State of Ohio Environmental Protection Agency

Re: Amended Closure Plan Approval  
DuPont Automotive Products Facility  
Container Storage Area  
OHD 005 041 843

Re: **Amended Closure Plan Approval  
DuPont Automotive Products Facility  
Tank 13  
OHD 005 041 843**

**Re: Notice of Deficiency  
Amended Closure Plan  
DuPont Automotive Products  
OHD 005 041 843**

PROP. SAMPLING PLAN  
CONT. STORAGE PAD

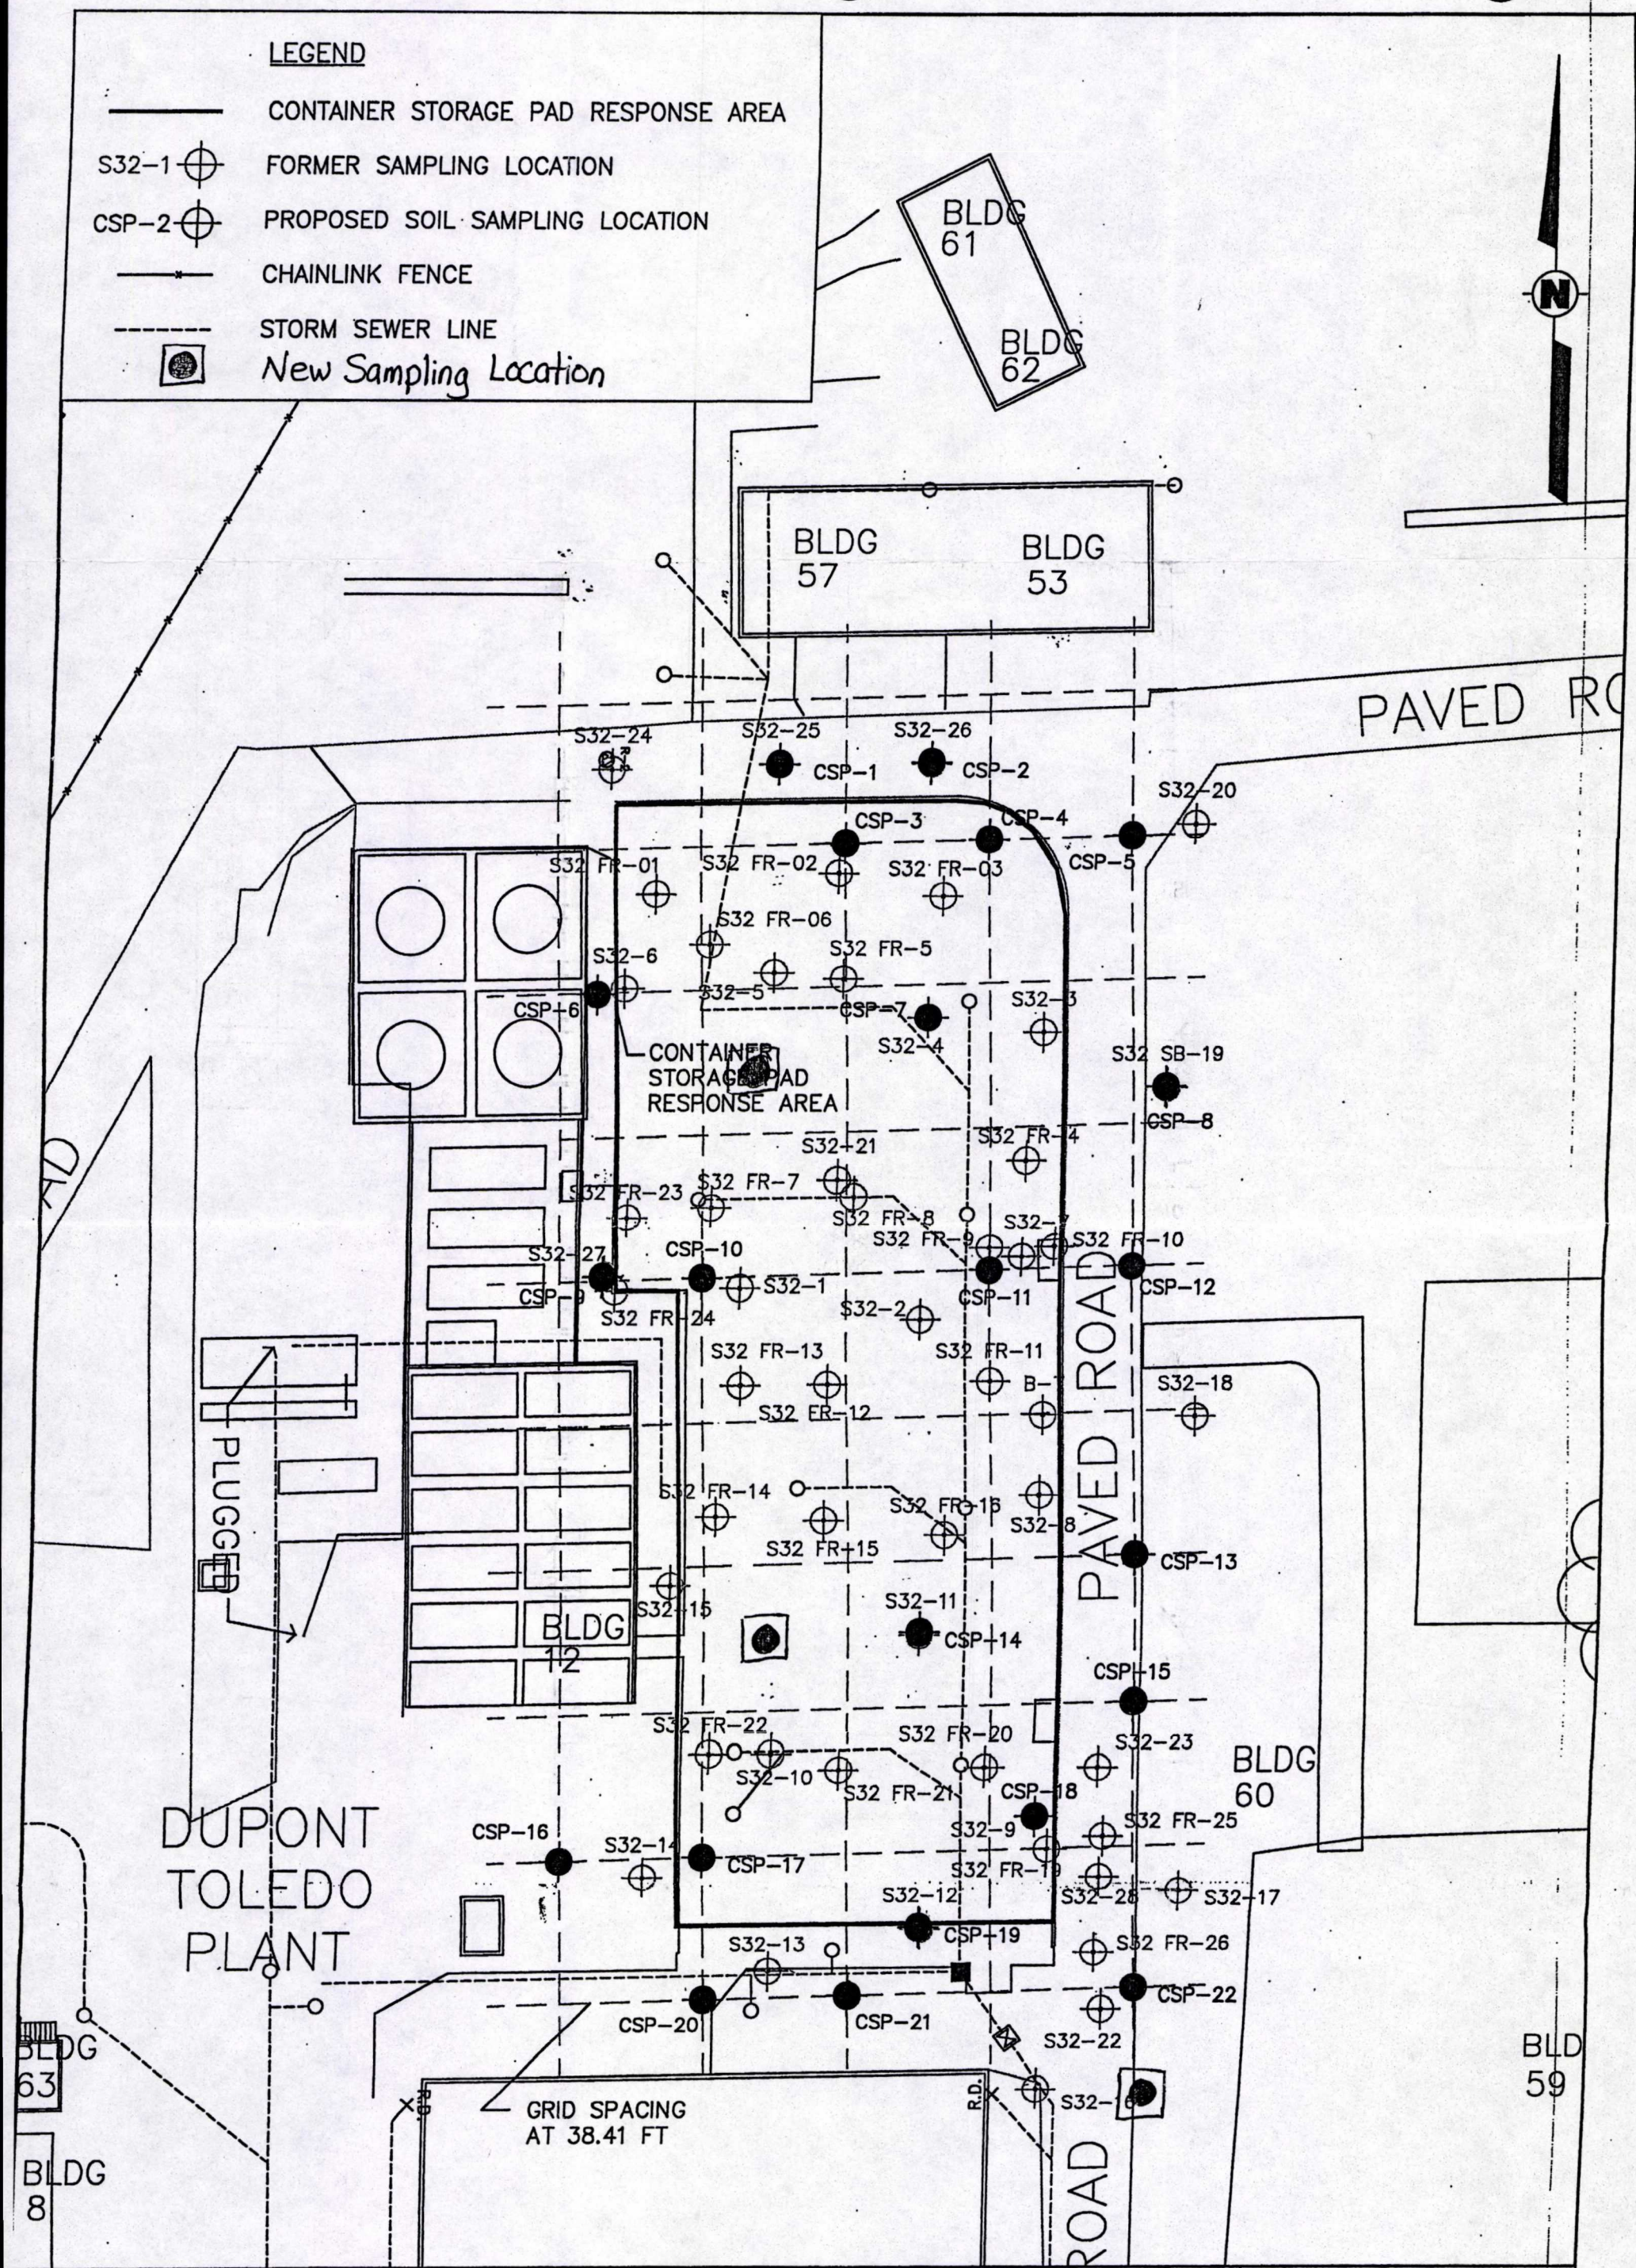
4. Appendix C, Soil Sampling and Analysis Plan, and Figure 14, Proposed Sampling Plan. Ohio EPA does not agree with the grid calculations in this appendix. However, Ohio EPA does agree with the sampling grid, sampling interval, and most sampling locations in the plan. The plan is hereby modified to include all sampling locations shown in the revised Figure 14 attached to this document.

TANK 13 RESPONSE AREA

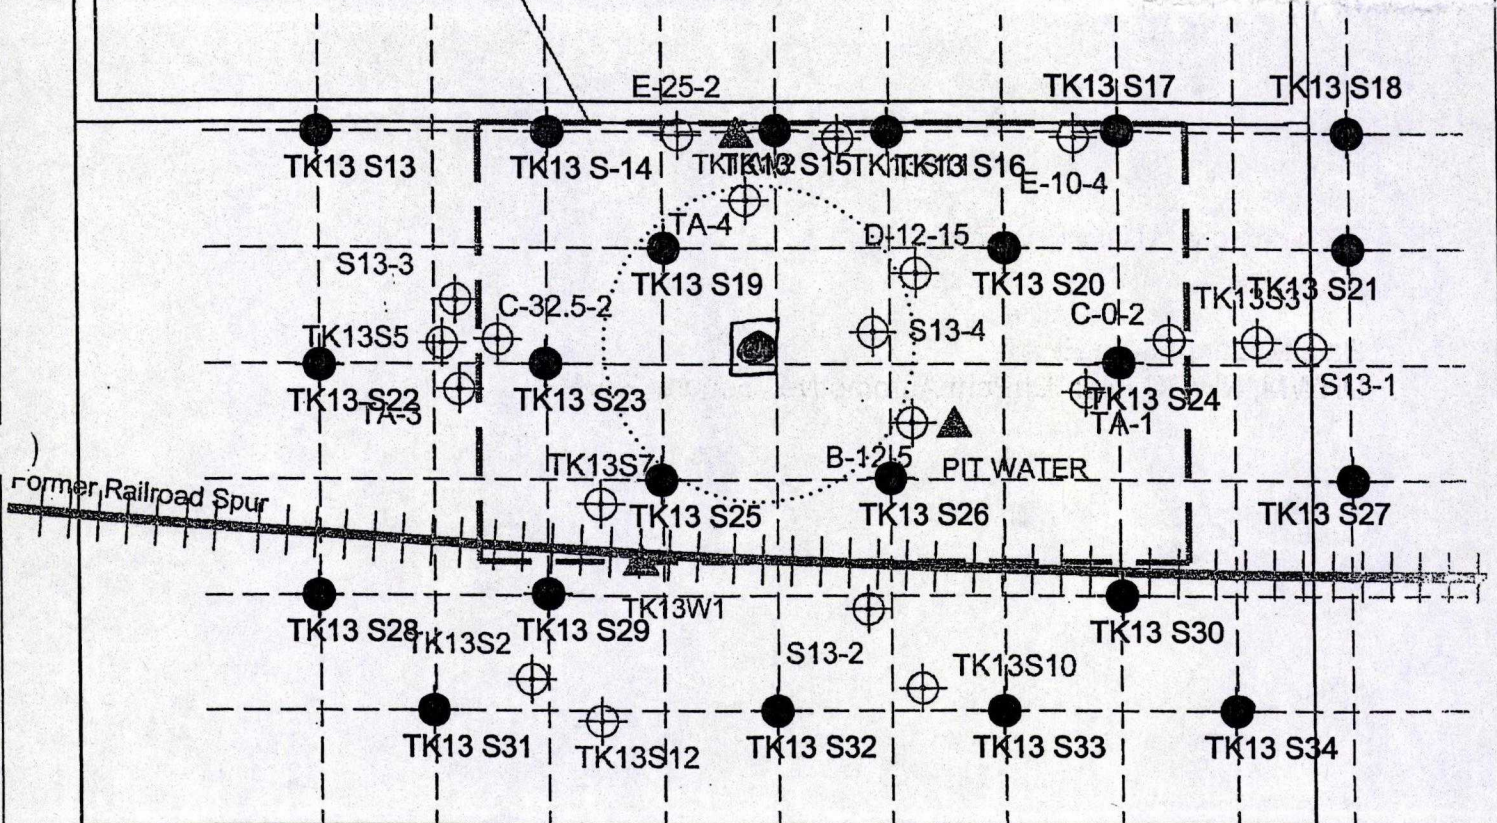
4. Appendix C, Soil Sampling and Analysis Plan, and Figure 14, Proposed Sampling Plan. Ohio EPA does not agree with the grid calculations in this appendix. However, Ohio EPA does agree with the grid interval, grid spacing, and most sampling locations in the plan. The plan is hereby modified to include all sampling locations in the revised Figure 14 attached to this document.
